CAMPUS PLANNING COMMITTEE RECOMMENDATION

TO	Paul Odenthal, Senior Associate Vice President for Administration
CC	Bruce Daley, Associate Vice President for UFIO Libby Ramirez, University Architect & Capital Resources Manager DS UR DS BD
FROM	Bob Richardson, University Land Use Planning Manager DS RR
DATE	December 14, 2022
SUBJECT	CPC Recommendation: Collaborative Innovation Complex (CIC), Schematic Design Approval

Proposed Site Plan

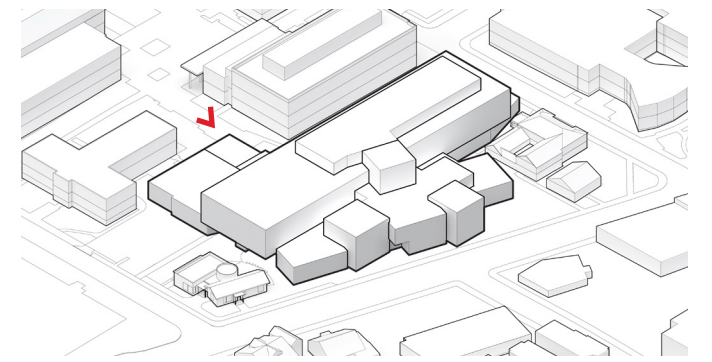
1. Memorial Place On-Street Parking – The parallel accessible parking proposed on Memorial Place creates conflicts with a south bound, contraflow bike lane on Memorial Place. As the site design is refined, this conflict must be resolved by relocating the proposed parking or reconfiguring bike facilities along Memorial Place.

3. Sidewalk Width and Placement – As shown in current schematic design drawings, the project is proposing a reduction in sidewalk widths along 26th Street and Memorial Place street frontages. Along Memorial Place, the design also modifies the existing curb-tight sidewalk placement to a sidewalk separated from the street by a landscaped tree planting area. The proposed sidewalk widths and the proposed placement of the Memorial Place sidewalk do not conform to recommendations in the OSU Transportation Plan and Corvallis Campus Vision. As the design is refined, sidewalk placement and width should align with recommendations in the OSU Transportation Plan. Where the existing sidewalk width exceeds the minimum sidewalk width recommendations in the OSU Transportation Plan, the design should maintain the existing sidewalk width.

West Entry

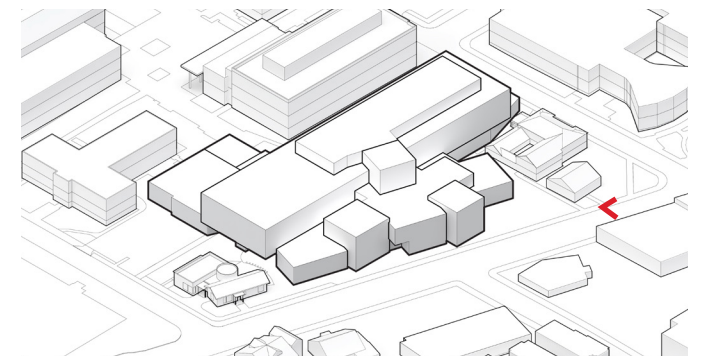
9. West Entrance Design – Given its distance from 26th Street and its location relative to the CEOAS Admin Building, the western entry has a limited presence from the 26th Street frontage. As the building design is further developed, strategies for enhancing this entrance should be considered and employed.
10. Roof Mounted Photovoltaic Panels – If roof-mounted photovoltaic panels will be used, their installation shall be consistent with all applicable requirements in the Corvallis Land Development Code.
11. Accessibility Best Practices for OSU – All elements of the building and site design, including the mobility hub and the Weniger Hall East parking lot (3222), shall comply with the 2010 ADA Standards for Accessible Design and Section 01 10 02 Accessibility Best Practices for OSU.
